## The Municipal Corporation of the Town of Fort Erie Special Council Meeting Agenda

8.2 PBBS-40-2025	7 - 143
Proposed Official Plan and Zoning By-law Amendments Information Report for lands located at 3856 Terrace Lane and Unassigned Parcel

**Municipal Address:** 3856 Terrace Lane & Unassigned Parcel 0-15097 Crystal Beach Drive, Fort Erie  
**Owner(s):** 1000054526 Ontario Inc. & 3101669 Nova Scotia Company  
**Applicant(s):** Robert Martin, P.Eng (Project Manager)  
**File Number(s):** ZBA-17-2024, OPA-08-2024

**Subject:** **Official Plan Amendment, Zoning By-Law Amendment – 1<sup>st</sup> Submission:**  
**3856 Terrace Lane and 0-15097 Crystal Beach Drive**

**Figure 1: The development superimposed on the WWTP.**

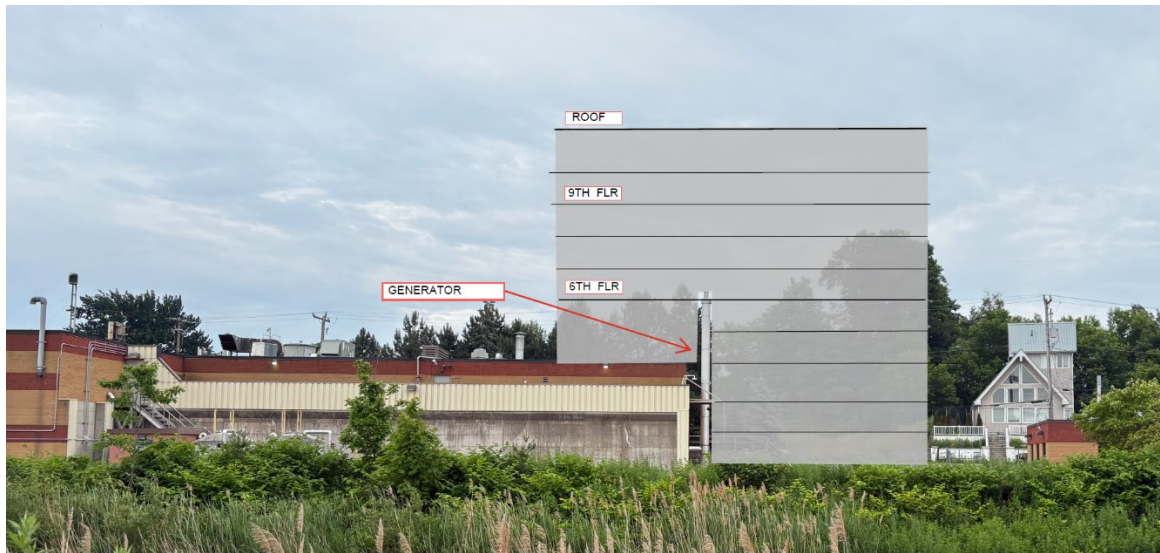
This is incorrect. The actual setback from Crystal Beach Drive is approximately 4.2 metres. The figure of 30 metres appears to reflect the distance between the proposed building and certain WWTP infrastructure, not the public roadway. Specifically, the closest WWTP building is approximately 28 metres from the proposed building, and the diesel generator stack is approximately 38 metres away. This discrepancy calls into question the accuracy of the spatial assumptions used in the odour impact analysis.

This underrepresents the potential impact. The diesel generator stack is 18 metres above grade at the WWTP, which itself sits approximately 1.5 metres below the proposed building's ground floor elevation. Therefore, the top of the stack would align roughly 16.6 metres above the proposed building's ground floor—approximately at the 6th floor level. As such, residents from the 6th floor upward would qualify as “elevated receptors” and could be exposed to emissions during periodic testing or emergency operation. This exposure warrants a more thorough evaluation than is currently presented.

See Figure 1 below.

The RWDI report’s treatment of the WWTP’s diesel generator operation is overly simplistic and does not adequately address real-world scenarios. The generator is not merely an emergency backup that operates infrequently—it is tested monthly for one hour and is relied upon during power outages. A notable example occurred during the week-long blackout that began around 3:30 p.m. on December 23, 2022. During that event, the WWTP’s emergency generator ran for approximately nine hours before failing due to a fuel shortage. This left the facility inoperable and raised significant concerns about public health and environmental protection.

Figure 2:

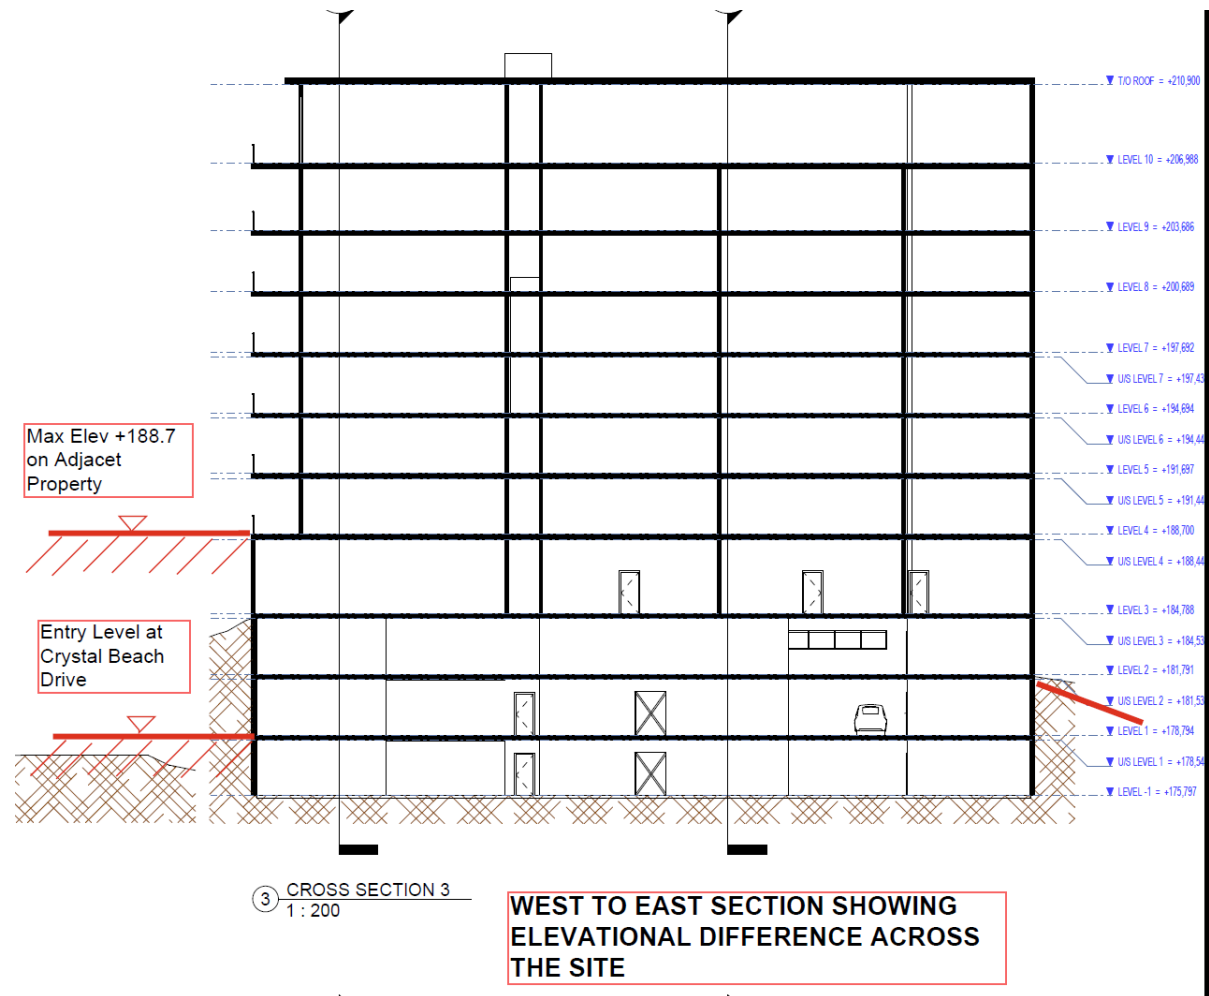
The report recognises that excavations will be to the property lines and that shoring will be required and *“the upper levels of the shoring system would have to be supported by a 'tie-back' arrangement drilled at an angle into the Cherty Limestone rock under the adjacent properties to the east and west and also under the road at Crystal Beach Drive where utilities have to be avoided.”* Alternately, should permission for tie-backs be refused by the adjacent property owners then a temporary raker and waler system of shoring within the confines of the property under development will be necessary, but would have to be removed when the concrete floors slabs are completed and have attained their specified strength.

Lateral soil pressure increases with depth so the lateral pressure from the west will be greater than the lateral pressure from the east which act facing each other. Tie-backs resist the lateral forces on each side. In the absence of tie-backs the unequal forces in opposite directions must be resisted by the structure and this would require significant east-west concrete shear walls which are not account for in the floor plans and would impede circulation within the below grade parking level and the first three floors above grade. See Figures 2 and 3 below.

**Figure 3: Existing Soil Profile Along West Property Line**

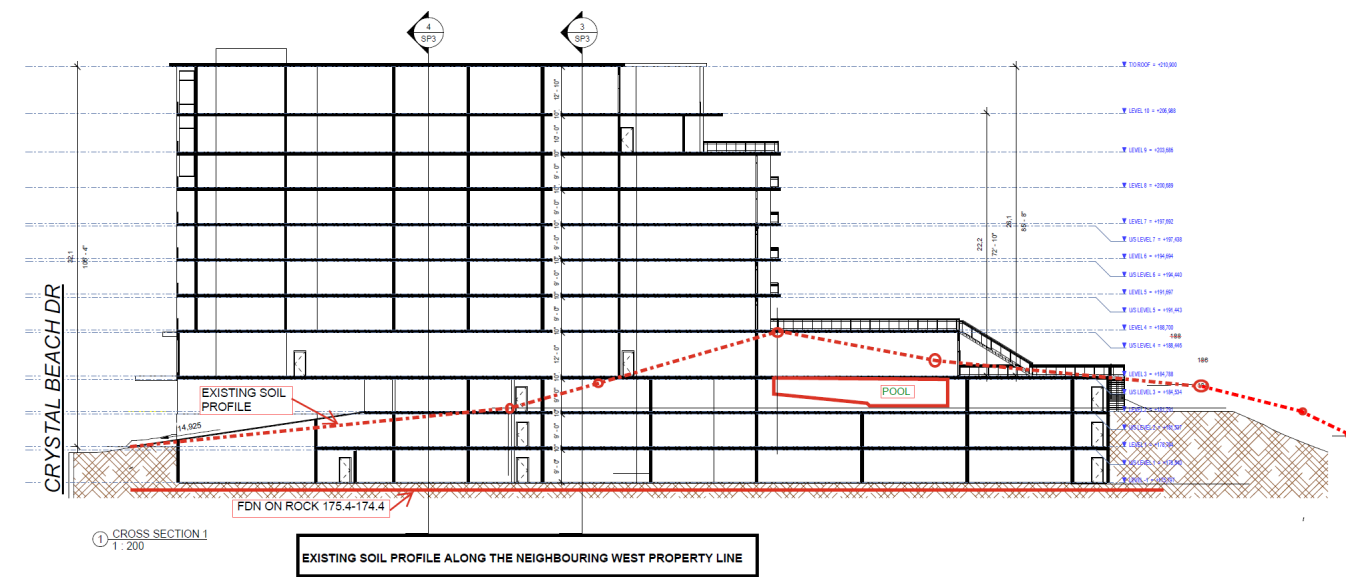
- the need for stabilisation of the sandy soil overlying the rock, and erosion control measures;

- “Unfortunately, because of the lot coverage there will be little vegetative stabilization (usually by planting native grasses, shrubs, and trees) which is a natural and effective way to anchor the soil and reduce surface erosion.”
- “Water management is equally important. Effective drainage systems, such as swales or French drains, help redirect water away from the site, reducing water saturation in the soil. Permeable surfaces and rainwater harvesting systems can further reduce surface runoff that might otherwise contribute to erosion.”
- “Ongoing monitoring and maintenance are essential after construction to ensure the long-term stability of the site.”
